Baseline Road Bridges at RWCD Canal and Floodway

PROJECT: Baseline Road Bridges over RWCD Floodway & Canal  
 S-R #: 281-247  
 CONTRACT NO. 82-30  
 DATE: December 9, 1982

ENTITLED: Baseline Road Bridges at RWCD Canal and Floodway

ADDENDUM NO. 2  
October 21, 1982

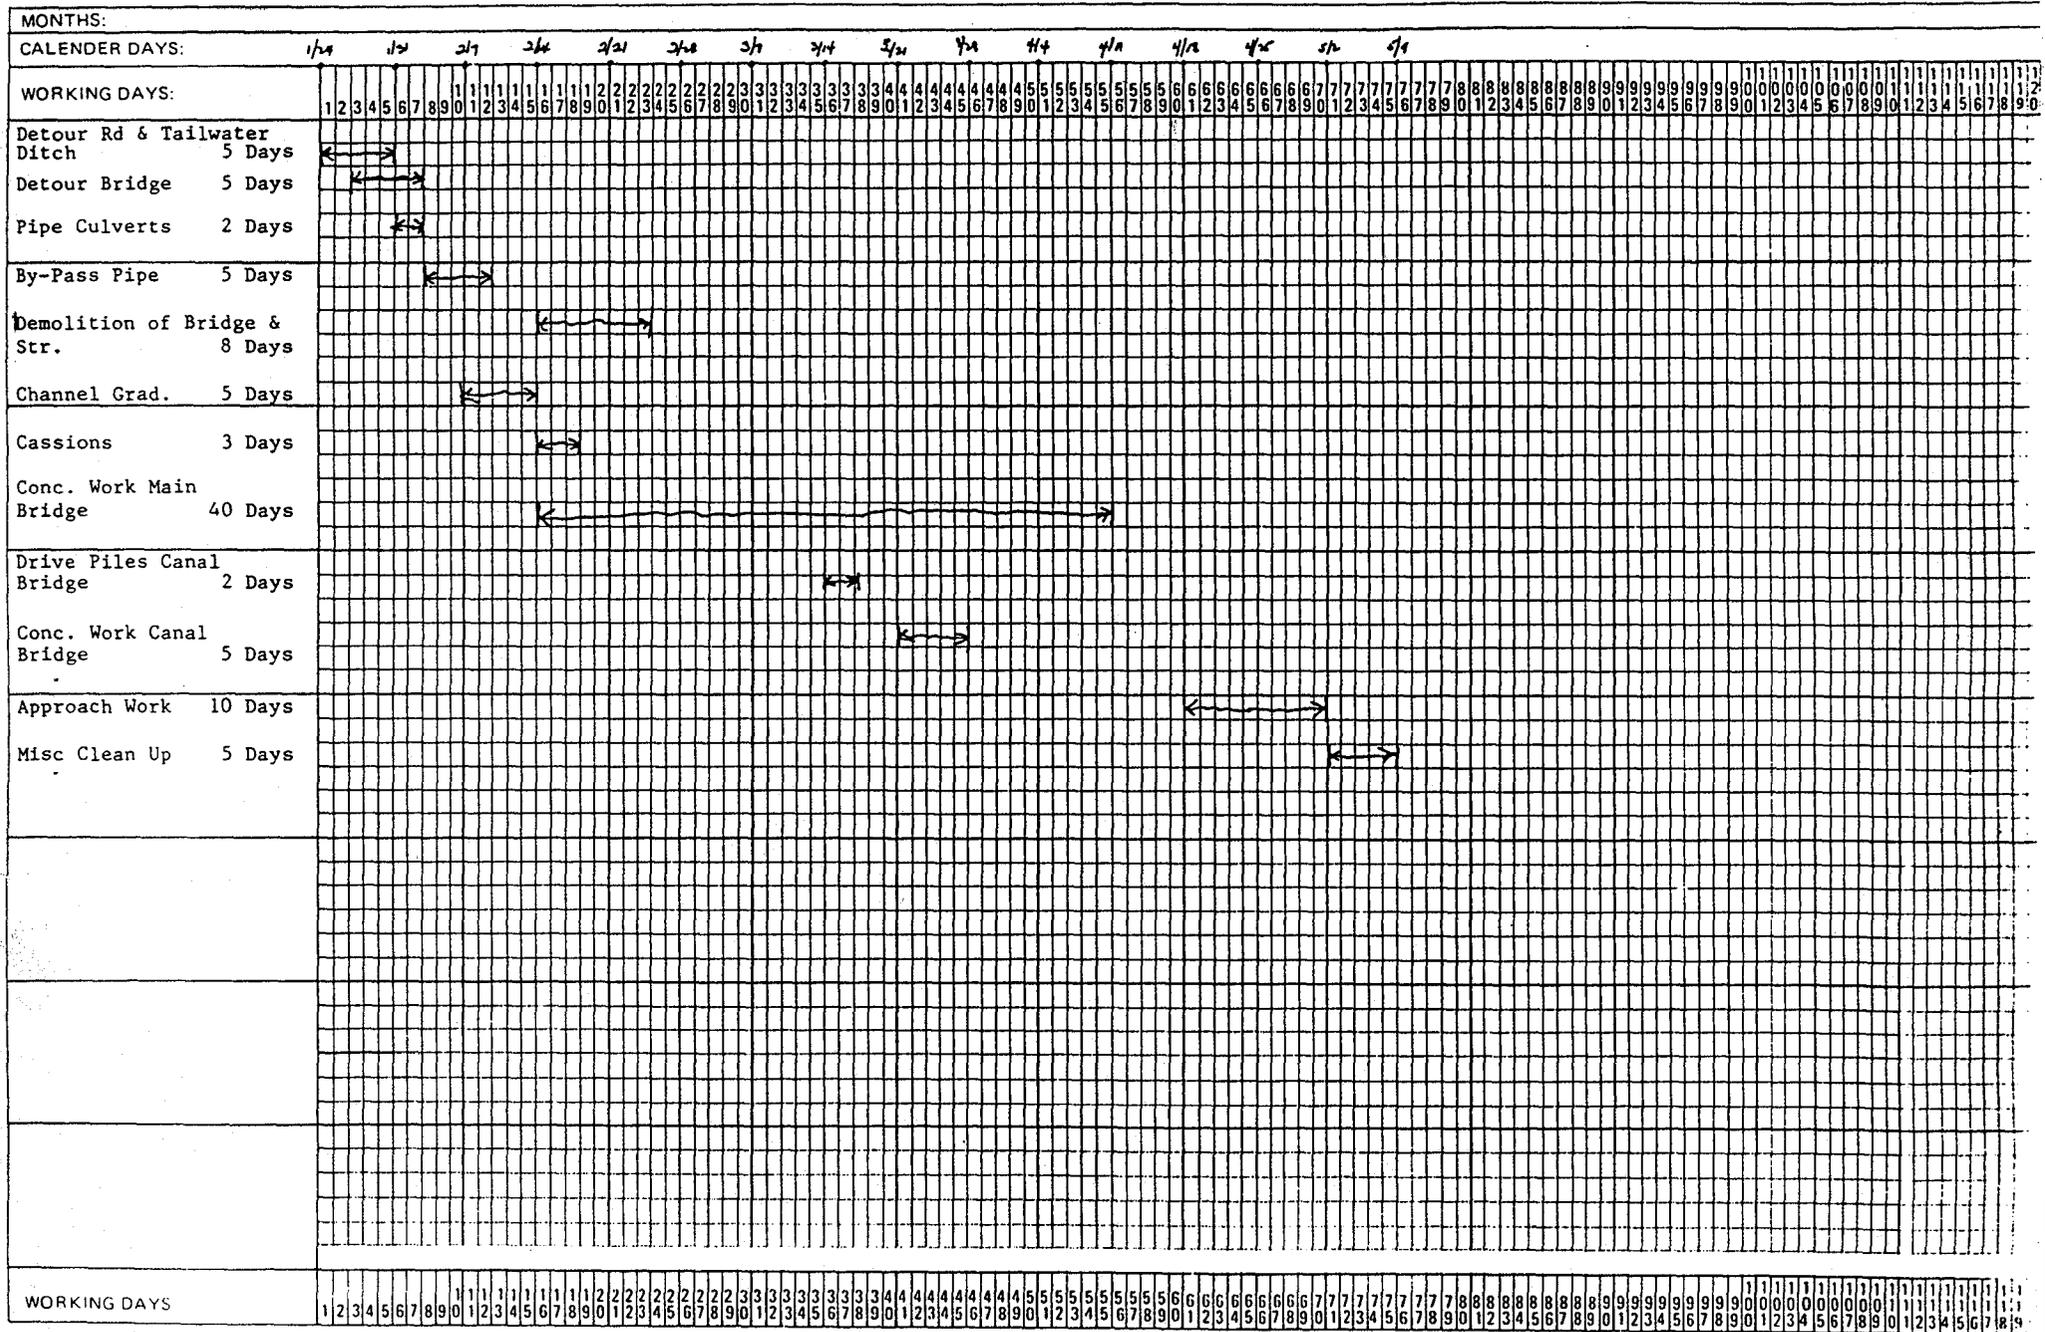
- Plot 13 of 22 (would like to land column down)  
in order to pull from straight up

- Baseline rd canal by <sup>(60")</sup> line, extend this  
~~instead of~~ and delete temporary bridge
